From: Kontron Embedded Modules GmbH
To: All Distributors and Customers
AN: #2_CRTtoLCD
Date: 10-Aug-05
Originator: Daniel Piper

Related Products: CRTtoLCD
Related Firmware : All

Reason for the notification:

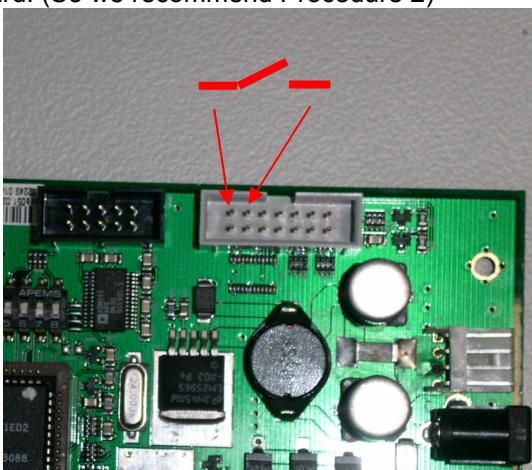
The board has to be started as usual (DIP-SW1=OFF), after start-up (without removing supply voltage) DIP-SW1 has to be switched to ON. Afterwards the board has to be restarted, that means a hardware reset has to be done (please see below).

Please Note: During the reset power supply has to be connected!

Now the flatpanel controller is in Firmware Update Mode and the firmware can be loaded up as usual with the Atmel Flip-Tool.

Procedure 2:

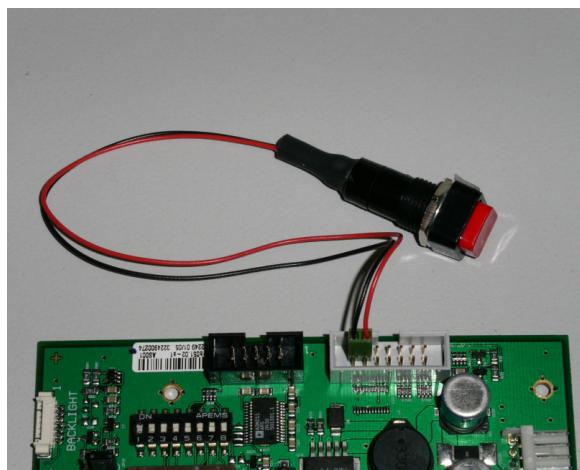
Best way is to use a push button. As described in Procedure 1 Pin11 and Pin13 of the OSD-Connector (CN102 at CRTtoLCD-2/-3 and X5 at CRTtoLCD-1-LC/TC) have to be shorted (GND). So a two-pole push-button has to be used. Please assure the correct position (!) on Pin 11 and 13! An unintended short-circuit can destroy the board!
